**SIGAR 20-21 Inspection Report**

## Kajaki Dam Irrigation Tunnel: The \$27.3 Million Tunnel Is Not Operating Properly Due to Construction Deficiencies and a Maintenance Issue

**JANUARY  
2020**

**Figure 1 - Cross Sectional Schematic View of the Kajaki Dam Irrigation Tunnel**

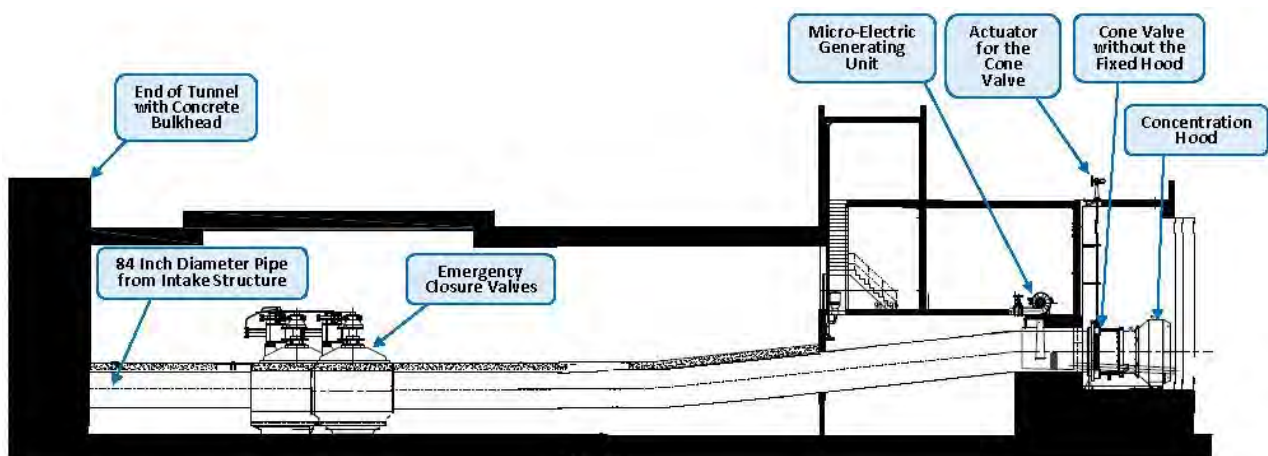
On January 30, 2013, the U.S. Army Corps of Engineers (USACE) awarded a \$25.6 million firm-fixed-price contract to Metag Insaat Ticaret A.S. (METAG), a Turkish firm, to repair the irrigation tunnel's intake structure, refurbish the emergency closure valve, replace the cone valve, and replace the micro-electric generating unit (see figure 1).<sup>2</sup>
